Work Order ID 157142***157142***

Item Name: AS350/AS355 Heli-Utility-Basket™ Long Version Split Lid - Fits LH or RH

DART SERVICE INSTRUCTION
TO AMEND INSTALLATION INSTRUCTIONS D350-607-1 REV. A AND
INSTRUCTIONS FOR CONTINUED AIRWORTHINESS ICA-D350-607 REV. 6
REF CANADIAN STC: SH94-14
REF FAA STC: SR00213NY
REF EASA STC: 10016996

**FIGURE 1: CHANGES TO FIGURE 2 OF D350-607-1 REV. A
AND FIGURE 25-1 OF ICA-D350-607 REV. 6**

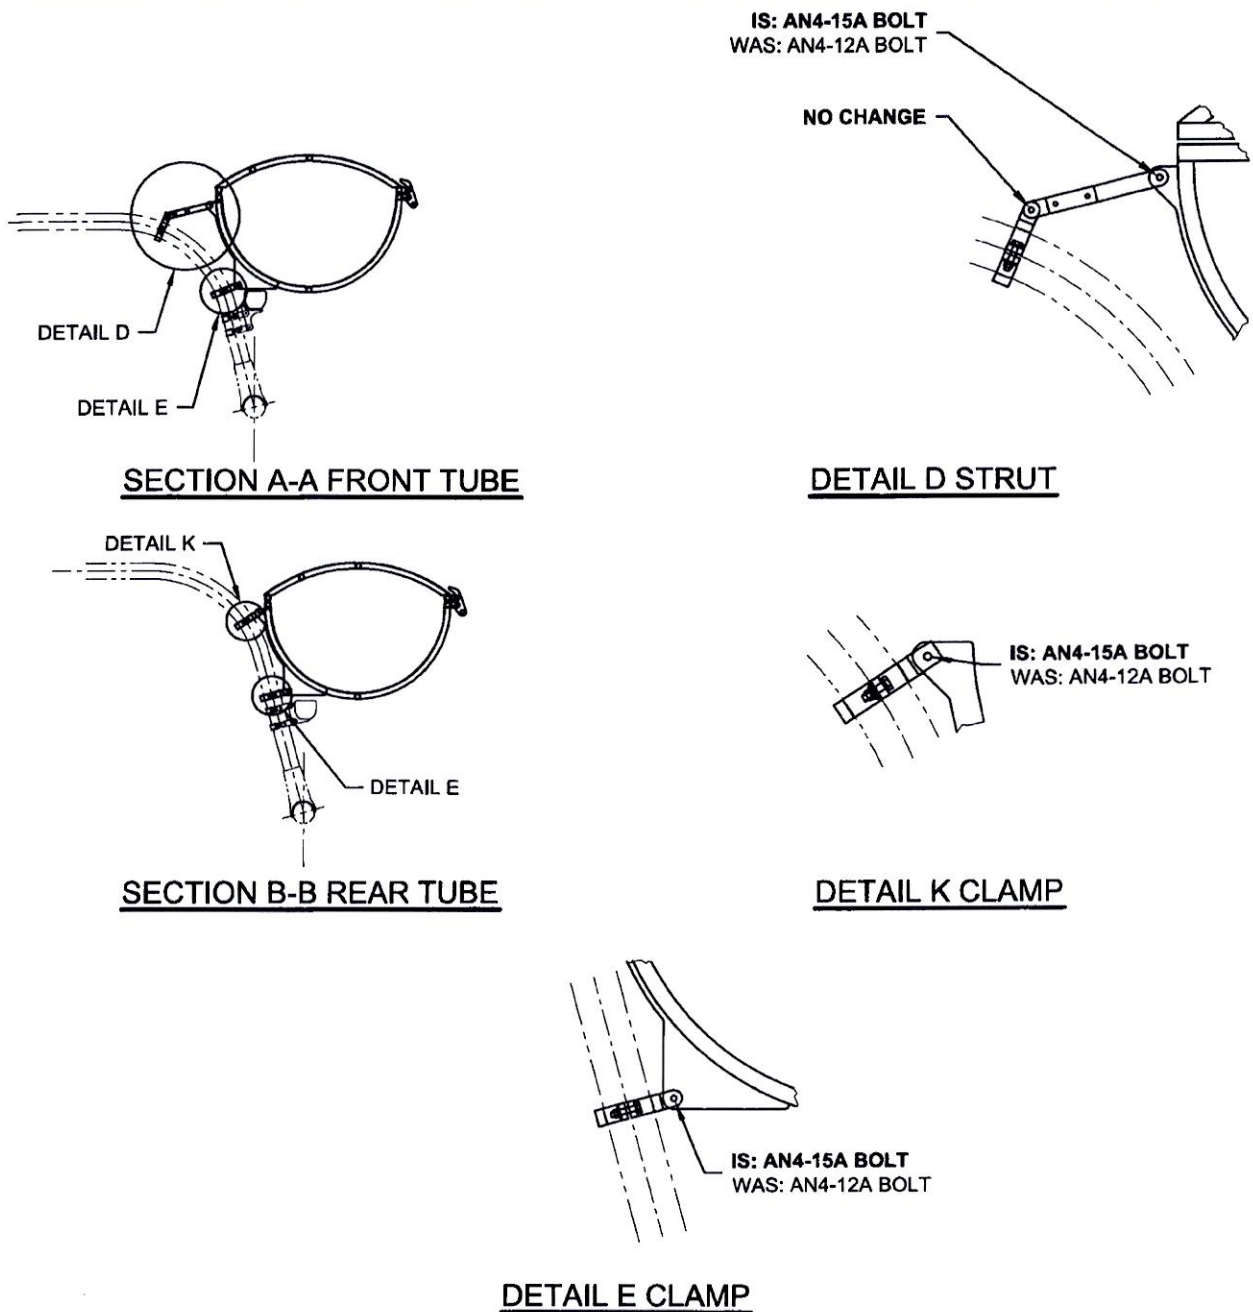
- 2.1 Sheet 2 of this DSI amends Figures 2 of D350-607-1 Rev. A and 25-1 of ICA-D350-607 Rev. 6;
- 2.2 Sheet 3 of this DSI amends Figures 3 of D350-607-1 Rev. A and 25-2 of ICA-D350-607 Rev. 6;
- 2.3 Sheet 4 of this DSI amends the Parts Lists of Installation Instructions D350-607-1 Rev. A (Sections 6.1 and 6.2) and ICA-D350-607 Rev. 6 (Sections 25.27.1 and 25.27.2).

SECTION A-A FRONT TUBE

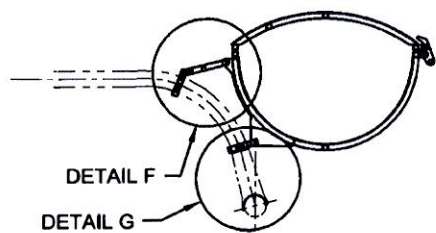
IS: AN4-15A BOLT
WAS: AN4-12A BOLT

DETAIL F STRUT

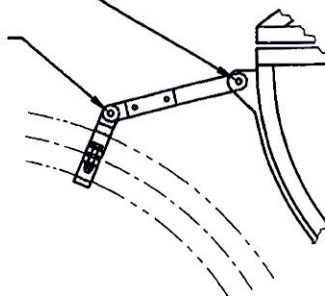
NO CHANGE

SECTION B-B REAR TUBE

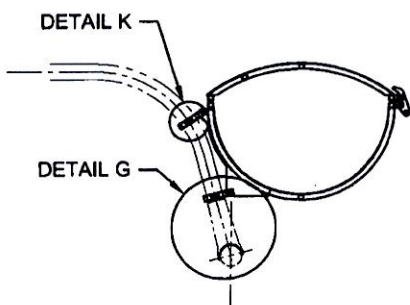
IS: AN4-15A BOLT
WAS: AN4-12A BOLT
